SERVICE KIT NO. SK-117

DATE: August 7, 1972
~~TITLE:~~
~~SUBJECT:~~ Flap Position Indicator Modification
 SERIALS AFFECTED: AA5-0001 thru AA5-0140
 WEIGHT AND BALANCE CHANGE: Negligible

Figure 1. Flap Position Indicator Modification.

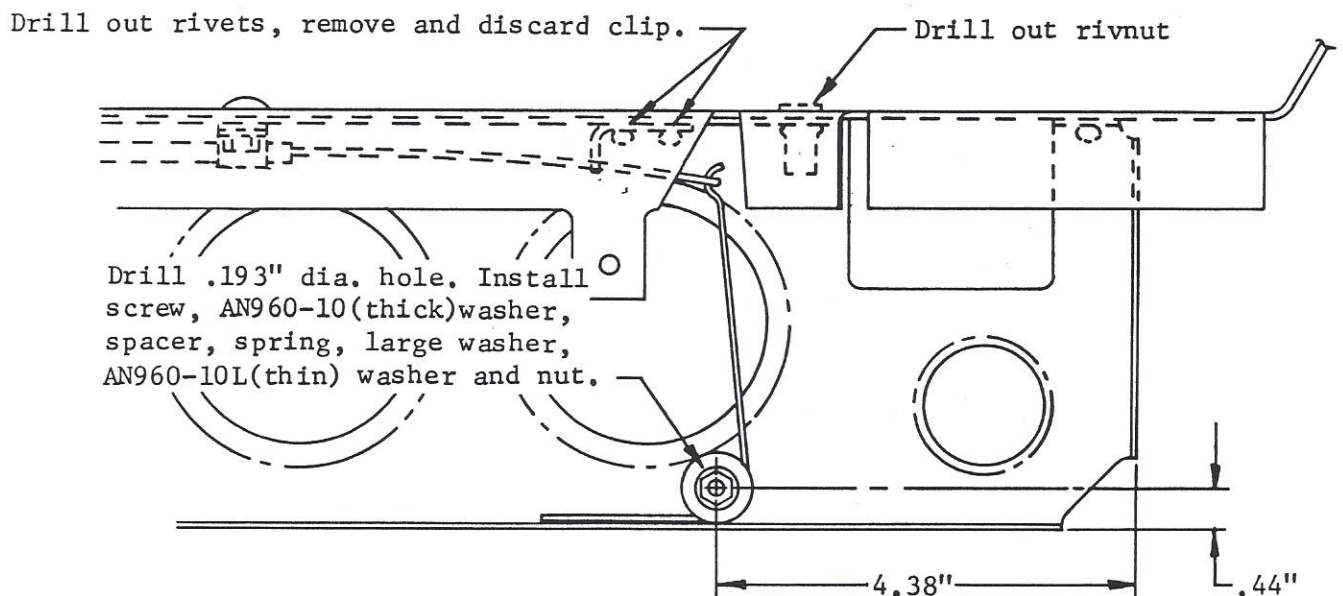
On production aircraft, AA5-0141 and up, the flap position indicator cable assembly has been redesigned to incorporate a return spring at the forward end of the indicator wire, inside the console. The addition of this spring provides a smoother, more positive flap position indicator movement. Aircraft below AA5-0141, which experience erratic flap position indicator operation, can be modified as follows:

6. Drill a .193 diameter hole through the console support to mount the spring. Locate as shown in Figure 1.
7. Install the spring retaining hardware in the following sequence: AN526-1032R-14 screw, AN960-10 washer, AES 201-6 spacer, 5604004-1 spring, A3235-028-24A washer, AN960-10L washer and the MS20364-1032 nut.

8. With the flaps fully retracted(0° position) pull indicator wire forward as far as possible and bend a small loop(approximately 1/8" radius) in the end of the indicator wire 1/2" aft of the ash tray cut out. Connect the return spring to the indicator wire and check for positive clearance with the ash-tray.
